09-AFC-3

Subject: Mariposa Energy Project (09-AFC-03)

Re: Comments to Staff Assessment November 2010, CEC 700-2010-017

Attachment No 1
Byron Airport (C83) RNAV Horizontal Protection Zones.

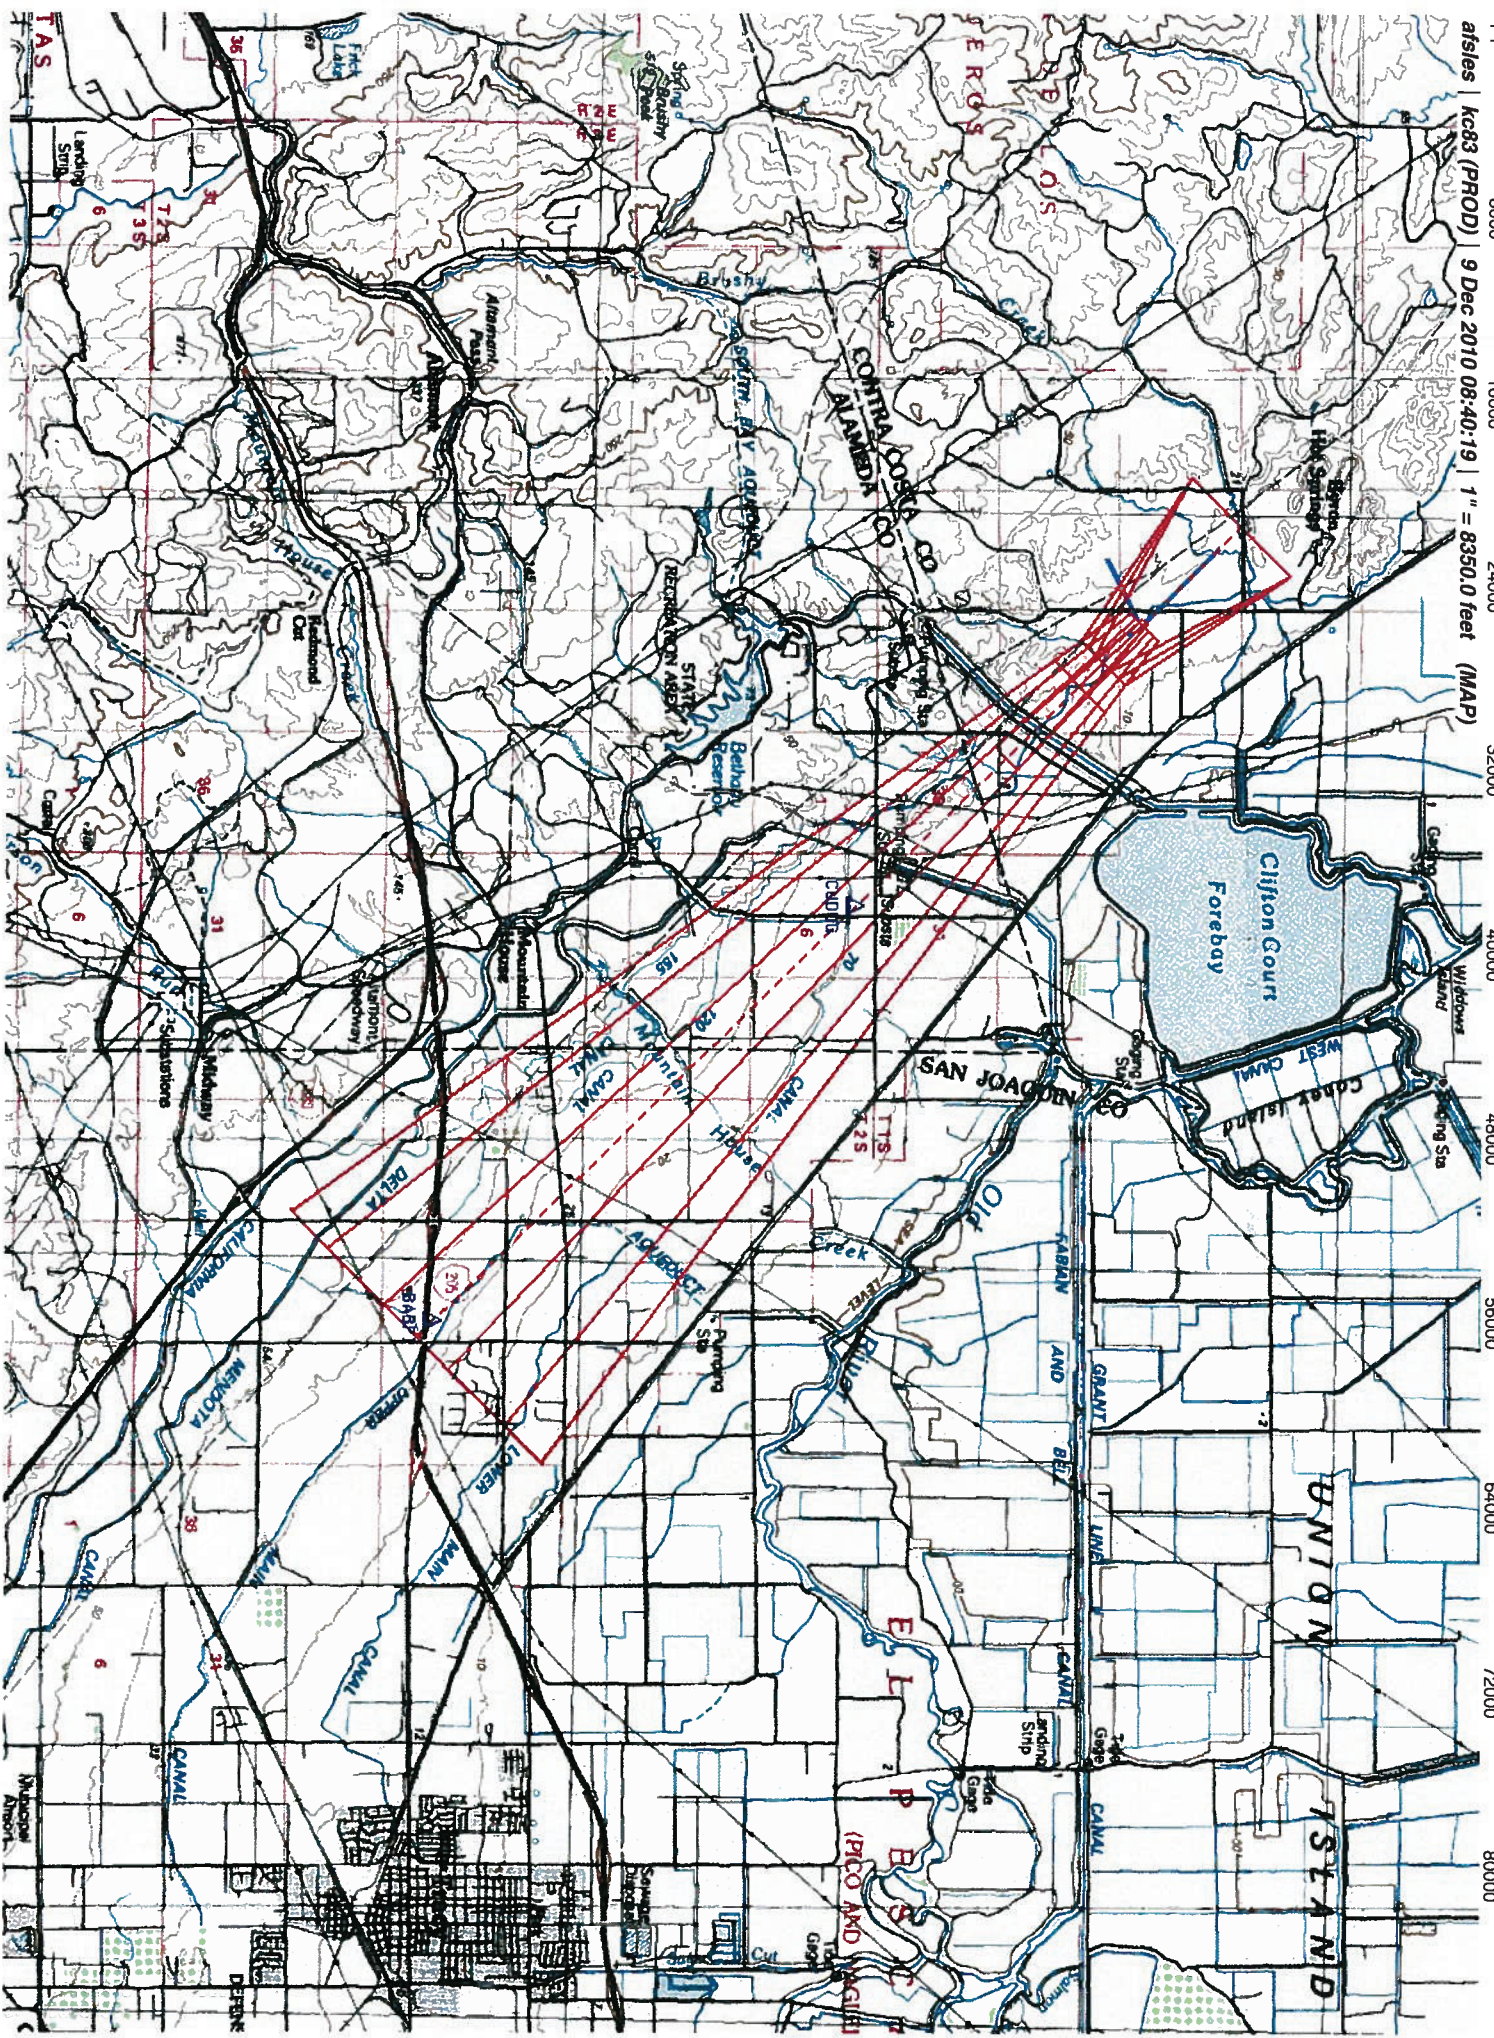
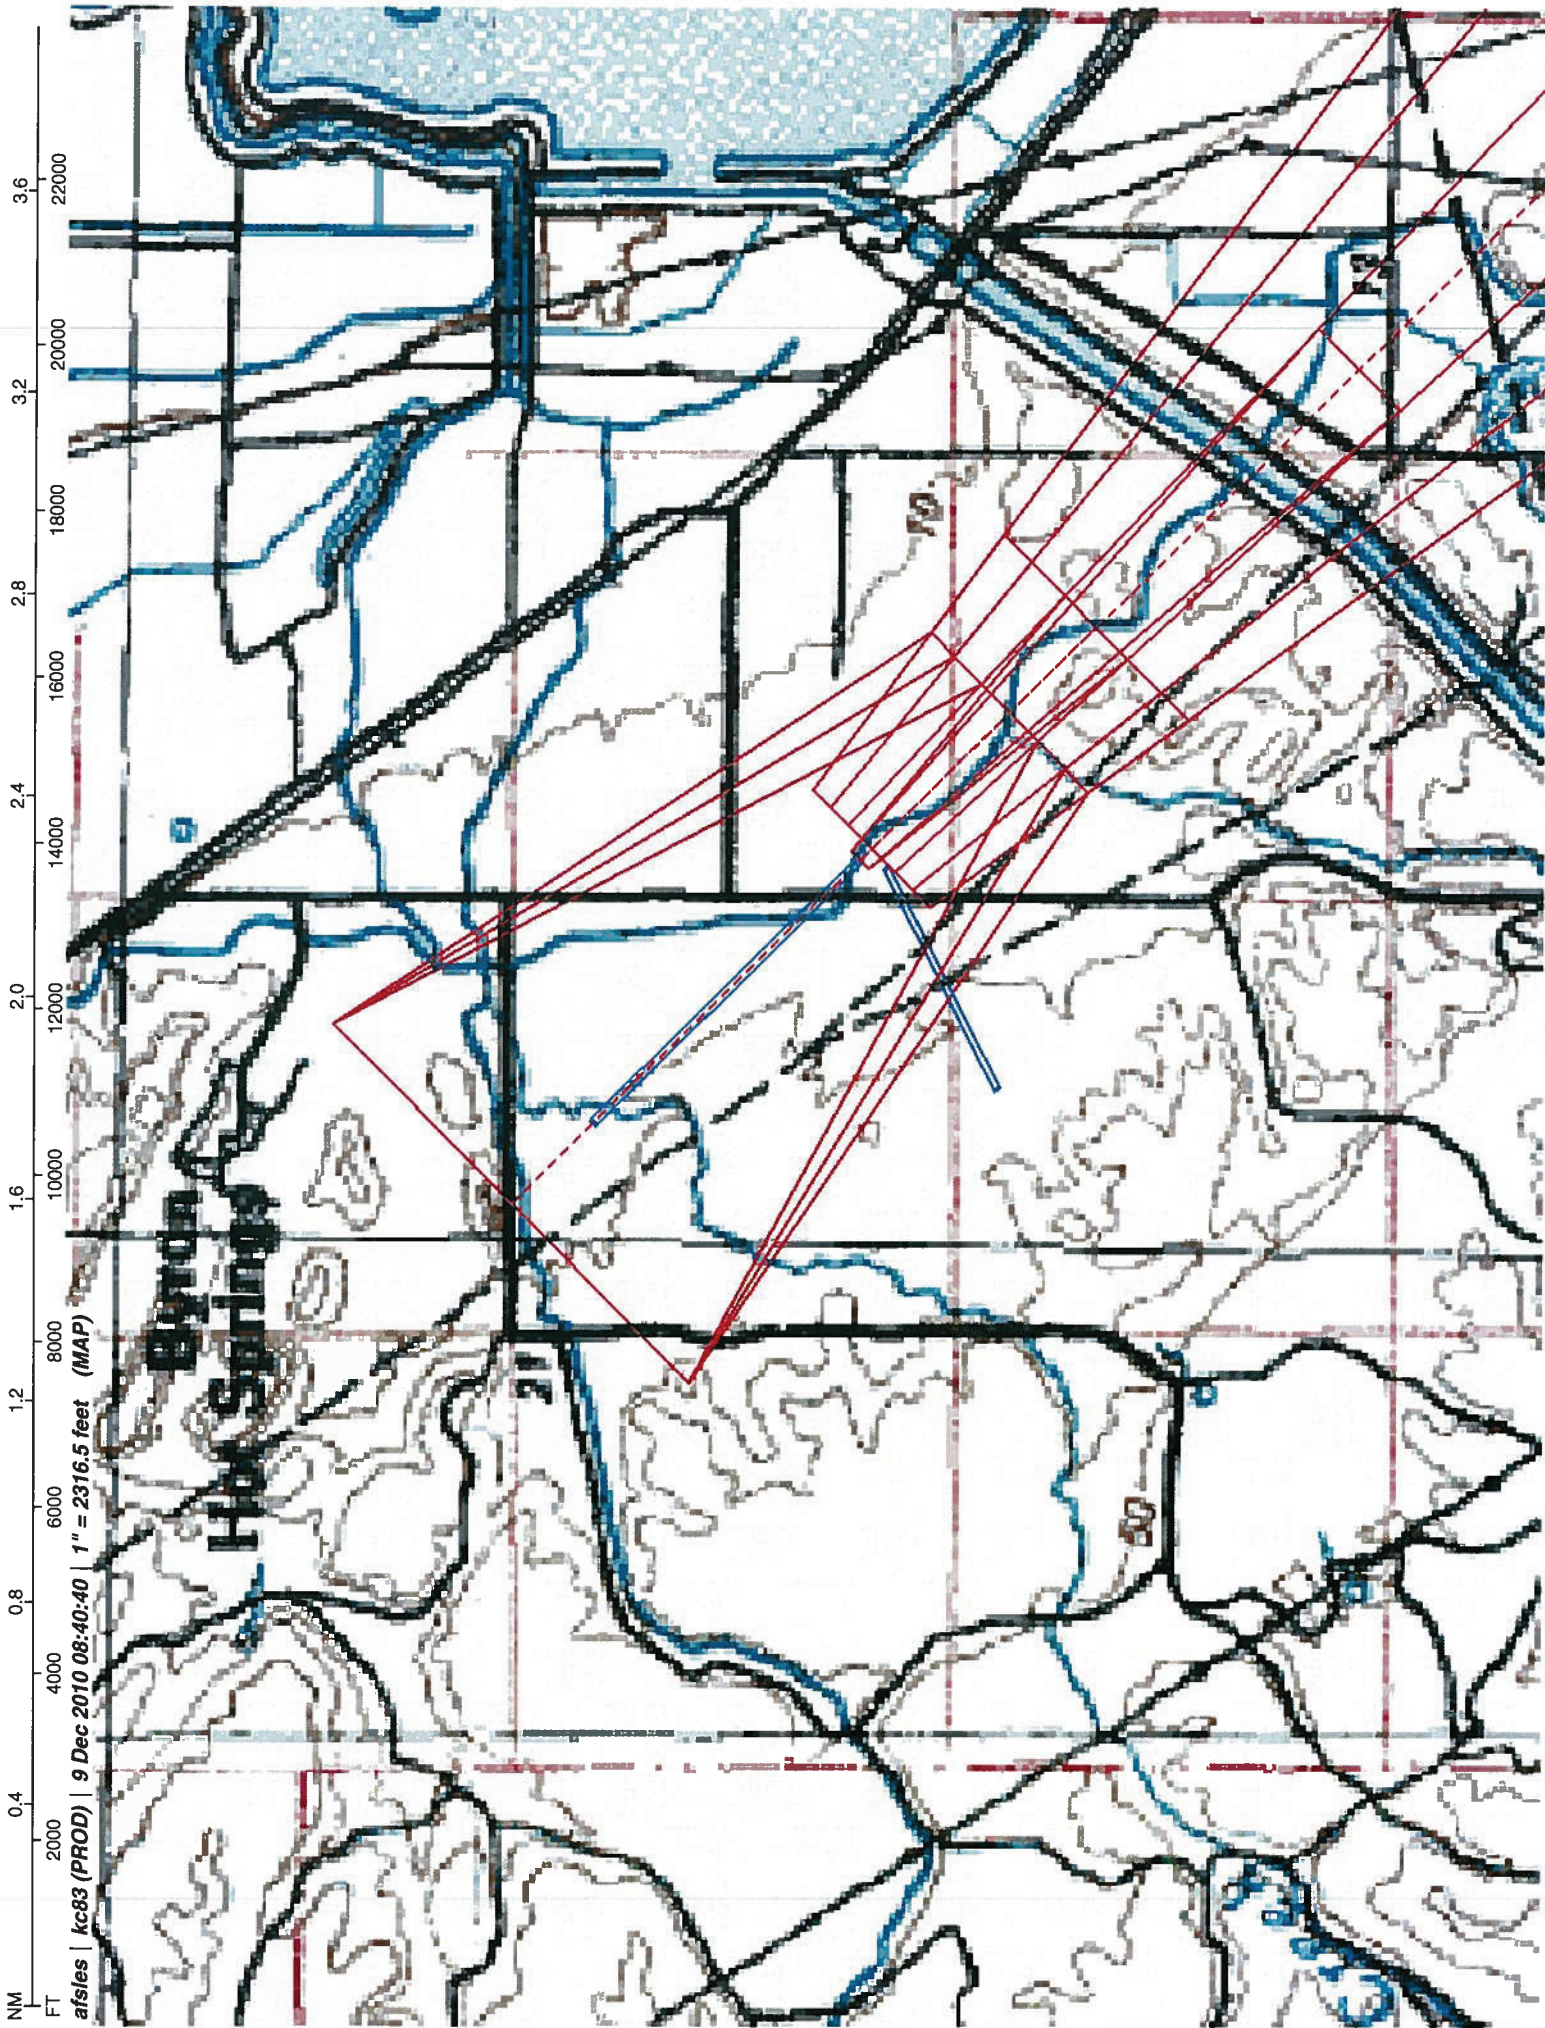
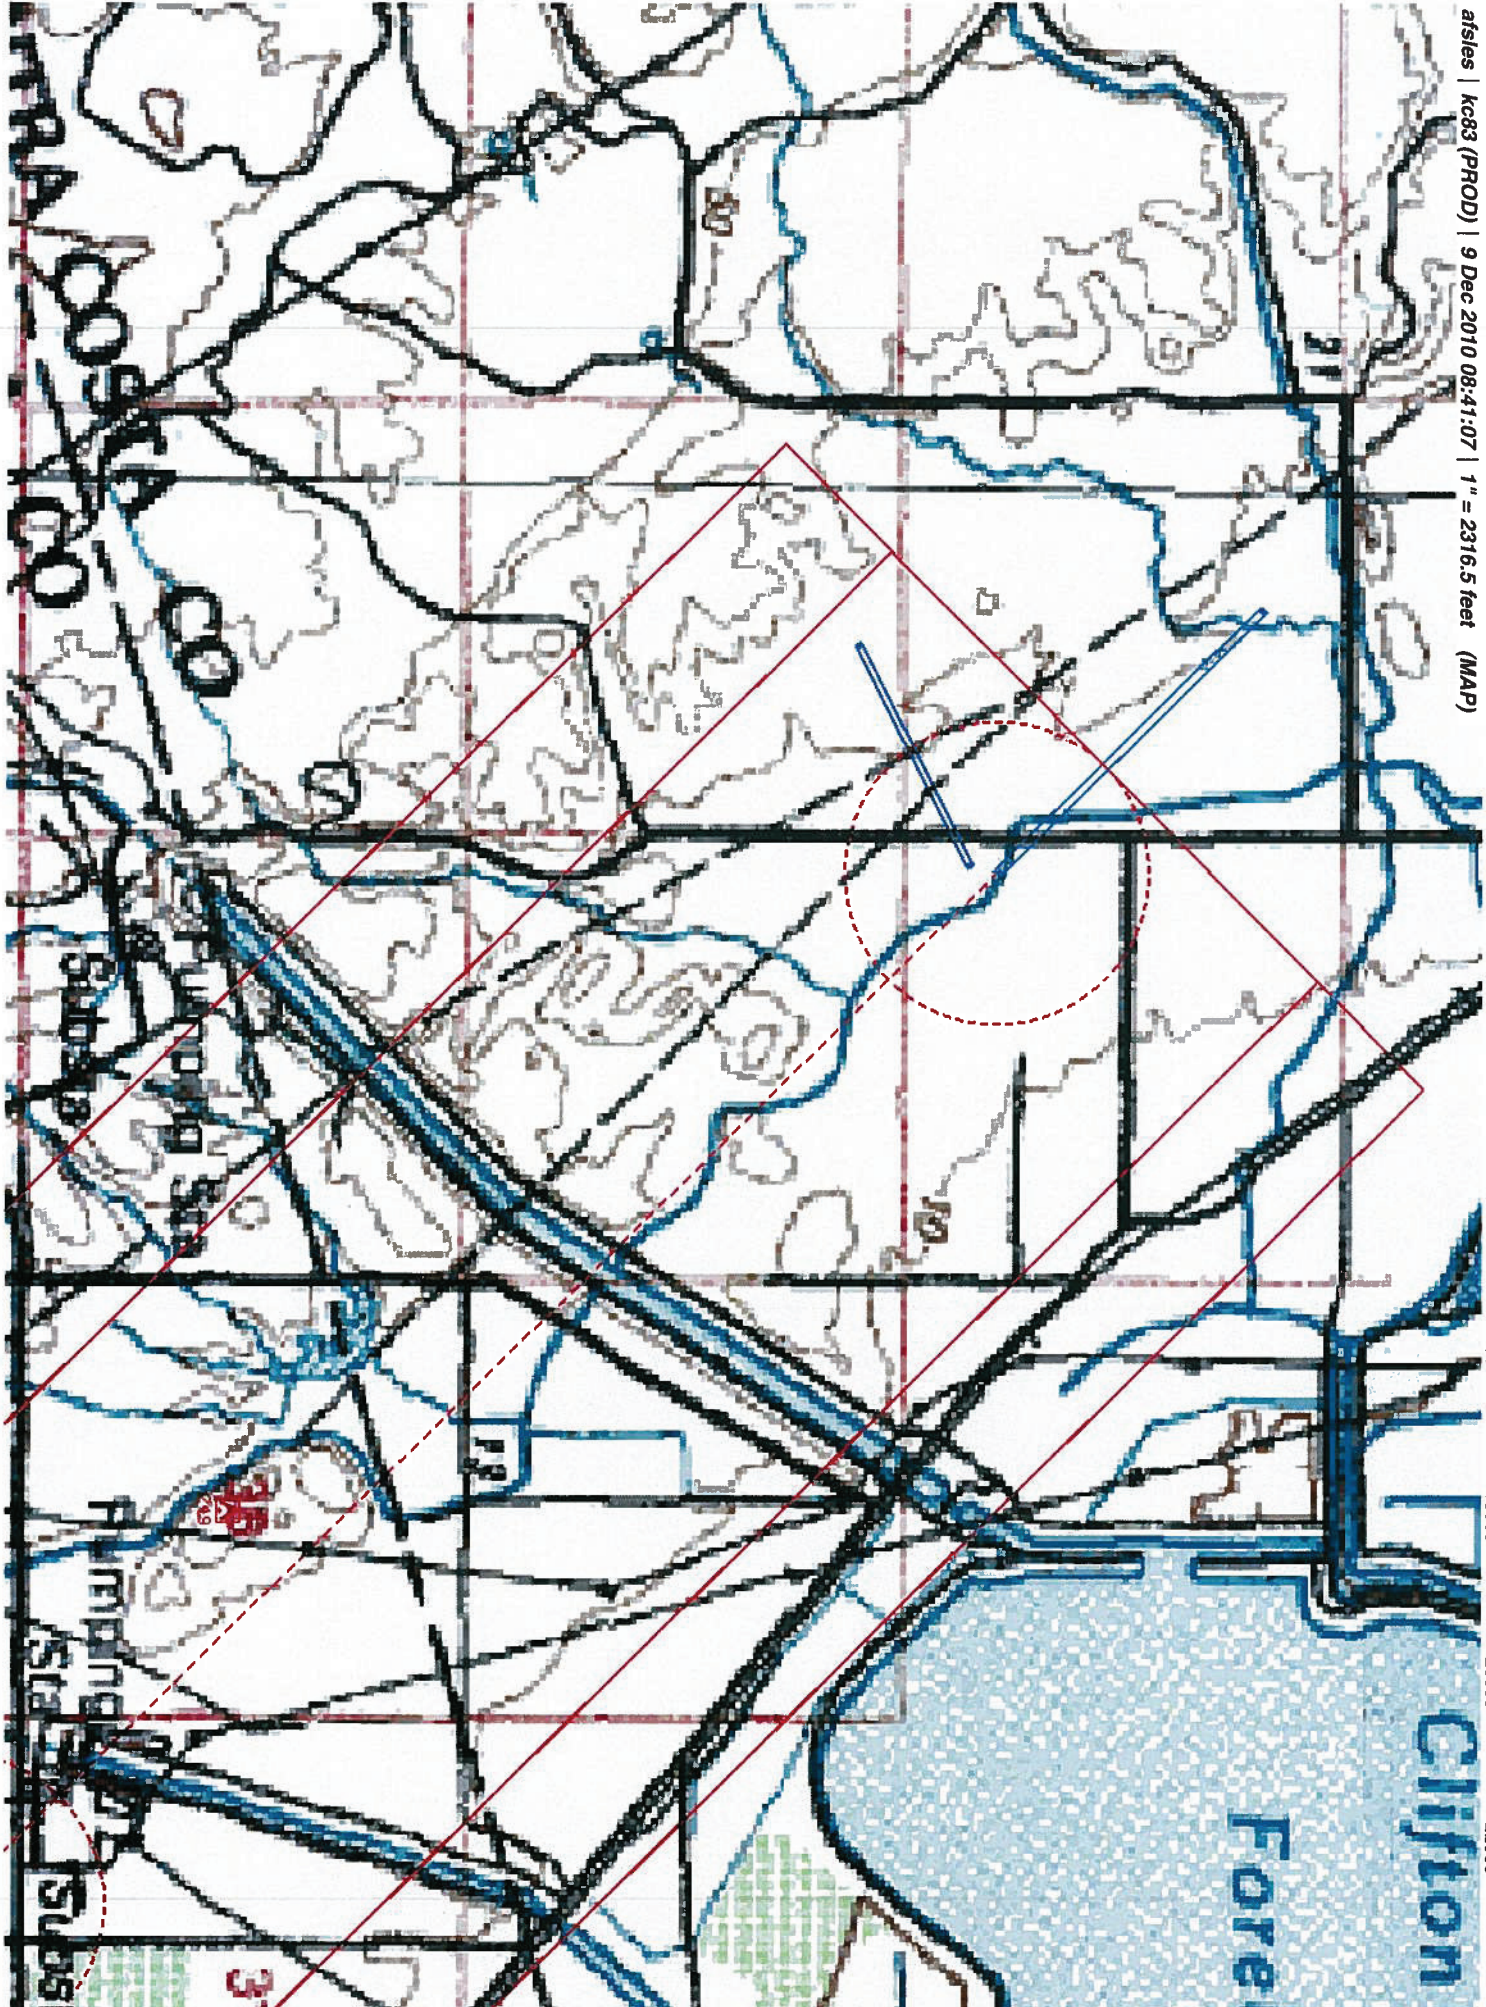
CALPILOTS Requests CEC Staff to review and calculate the horizontal obstacle / hazard clearance to the RNAV Approach to the Byron Airport (C83) RNAV Approach to Runway 30 (Attachment 1) and as per U. S. Department of Transportation, Federal Aviation Administration (FAA), National Policy, Order 8260.54A, And Effective Date: 12/07/07, Subj.: The United States

This should be applied but not limited to Mariposa Energy and East Altamont. East Altamont would not only have the invisible thermal plumes but the visible plumes as well. Both would interfere with the Obstacle Clearance Surfaces to Runway 30.
